UNITED STATES PATENT AND TRADEMARK OFFICE

10/520,218

Office Action Summary	Application No. 10/520,218	Applicant(s) BREITSCHWERDT ET AL.	
	Examiner MARC ARMAND	Art Unit 2814

2. **Claims 22-30,39,43,44,51 are rejected under 35 U.S.C. 103(a) as being unpatentable over Geusic et al., (Geusic) USPAT 6,198,168 in view of Wen et al., (Wen) USPAT 6,207,903.**

FIG. 8

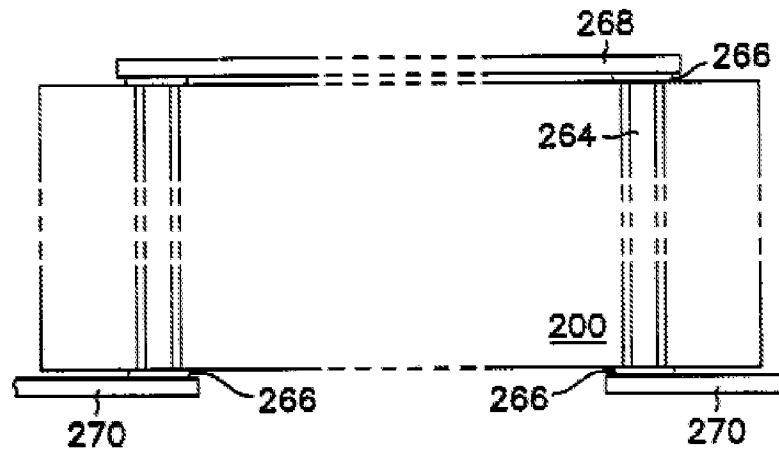
As per claims 22, 24, Geusic shows in fig. 8 and discloses (col.5, line 60-68) and (col.6, line 1-10) an electrical component, having a first metallization layer (268) (applicant's conductive structure); a second conductive structure (270); at least one via (264) (applicant's feedthrough); a substrate (applicant's base element) provided with at least one via (268) (applicant's feedthrough) that connects the first conductive structure (268), the first conductive structure extending on or in a vicinity of an upper side of the base element (200), to the second conductive structure (270), the second conductive structure (270) extending on or in a vicinity of a lower side of the base element (200) and includes a first conductive structure (268) and a second conductive structure (270).

As per claim 25, Geusic shows in fig. 8 and discloses (col.5, line 60-68) and (col.6, line 1-10) that the electrical component has at least one via (applicant's feedthrough) is one of filled and lined with an electrically conductive material corresponding to a metal.

As per claim 26, Geusic shows in fig. 8 and discloses (col.5, line 60-68) and (col.6, line 1-10) that the electrical component has the substrate (200) (applicant's base element) that is flat at least in a vicinity of the at least one via (applicant's feedthrough), and the at least one feedthrough extends perpendicularly to a plane spanned by the vicinity of the base element that is flat and penetrates through the substrate (200) (applicant's base element).

As per claim 27, Geusic shows in fig. 8 and discloses (col.5, line 60-68) and (col.6, line 1-10) that the electrical component has at least one via (264) (applicant's feedthrough) with a conductive material.

As per claim 28 Geusic shows in fig. 8 and discloses (col.5, line 60-68) and (col.6, line 1-10) that the electrical component has at least one via (applicant's feedthrough) that is rectangular in plan view.

As per claim 39, Geusic shows in fig. 8 and discloses (col.5, line 60-68) and (col.6, line 1-10) that the electrical component having vias (264) and conductive structures, a first vias (264) (applicant's feedthrough), a second feedthrough (264), and a third feedthrough (264)

As per claim 43, Geusic shows in fig. 8 and discloses (col.5, line 60-68) and (col.6, line 1-10) that the electrical component has an electrical component provided on an upper side of the substrate (200) (applicant's base element) and capable of being electrically activated by way of the at least one via (264) (applicant's feedthrough) from the lower side of the substrate (200) (applicant's base element)

As per claim 29 and 30, Geusic shows in fig. 8 and discloses (col.5, line 60-68) and (col.6, line 1-10) a via (264) with a width a diameter and also an area.
